December 14, 2001

**RE: Sealed Source Registration for MDS Nordion C-168**

Thank you for your e-mail of November 20, 2001, in which you requested additional information. Please find below the response to your questions.

**Figure A Serial Number 0001 Section, Polished (43x Magnification)**

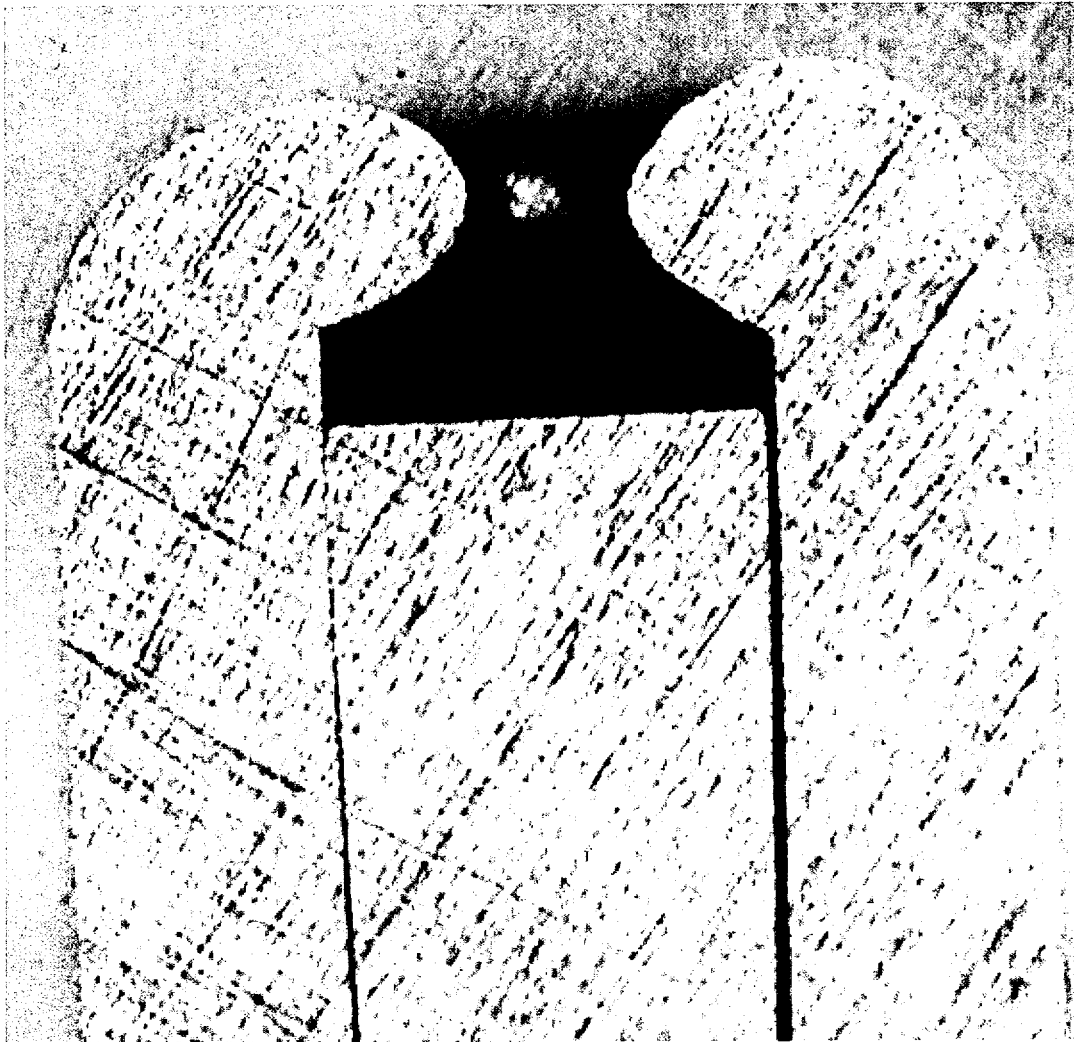
10. The Capsule Testing Work Sheet for the Vibration test, you reference an Appendix A concerning an extended length capsule which bubbled in leak testing. Please provide a copy of the Appendix A referenced by the work sheet.

An extended length capsule was used to ensure adequate free air space for the validity of the Helium Leak Test. The extended length capsule contains a pellet and a spring between the pellet and the plug. The spring has a diameter of 0.016". In one case, serial number 0001, the spring came off the pellet during handling and lodged beside the pellet allowing the plug to drop down. As a result, the welding was done without fusing the plug as seen in the polished section in Figure A below. This made it impossible to complete a vibration test on a second unit.

The spring is used to support the plug only for the longer capsule. During planning of the tests using an extended capsule length, it was proposed to use a spring to ensure sufficient free air space for helium leak testing, but a deficiency resulted from using the spring. The longer capsule with a spring is not used in production, but only for validation of the helium leak test. This fault could not happen in C168 production because a spring is not used.

**Figure 1 Serial Number 0007 Weld (76x Magnification)**

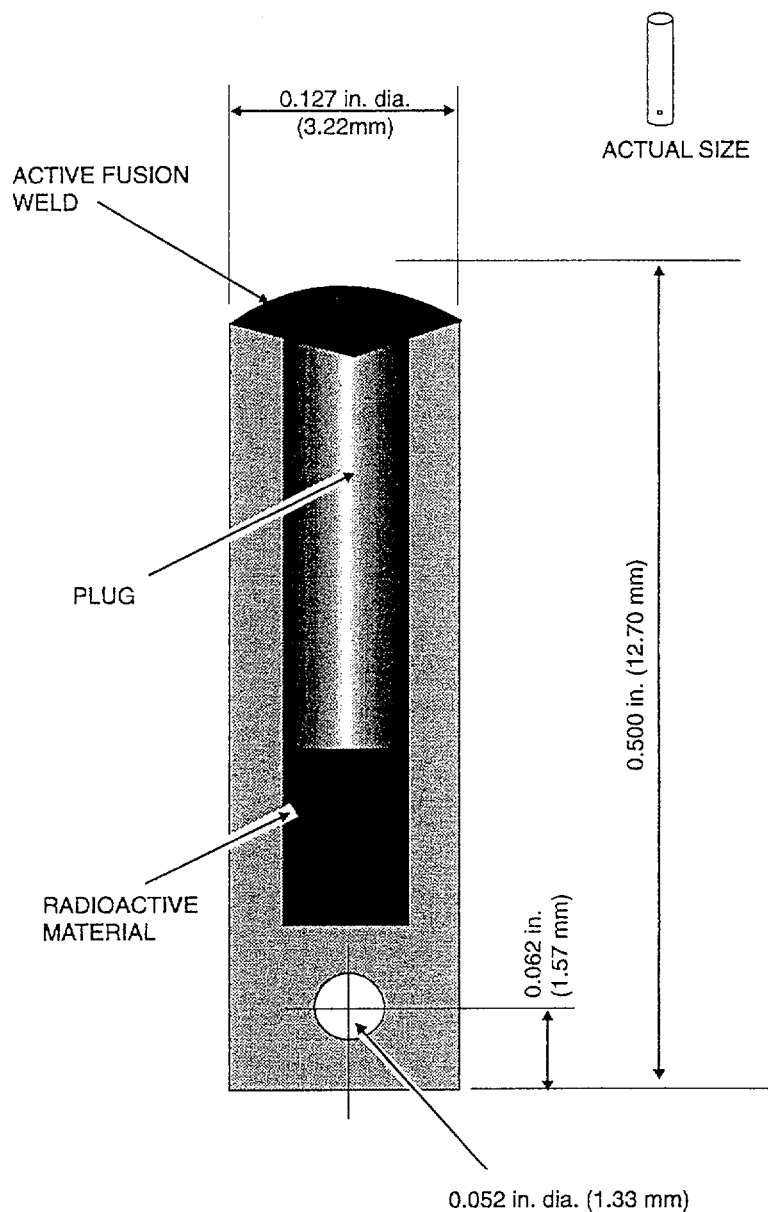
8. In the TESTING OF PROTOTYPES section, page 3, you state that one test capsule, number 0007, "had a degraded surface condition that resulted in an inconclusive helium leak test." Additionally, in the CAPSULE TESTING WORK SHEET for the temperature test, you stated that the helium leak test "results were inconclusive see appendix B." Please provide additional information on the degraded surface condition, specifically, what it was and why it prevented a successful helium leak test. Also, please provide a copy of the appendix B referenced by the work sheet.

During the temperature test the surface of the extended length capsule greatly degraded. As seen in Figure 1 below, the weld of serial number 0007 has a lot of scale and loose surface material. The rough surface condition resulted in helium becoming absorbed and trapped in the surface of the capsule. This surface condition resulted in inconclusive helium leak test results. The solid bar dummy also did not pass the leak test. As a result the Liquid Nitrogen-Alcohol Bubble test was used to qualify these capsules.
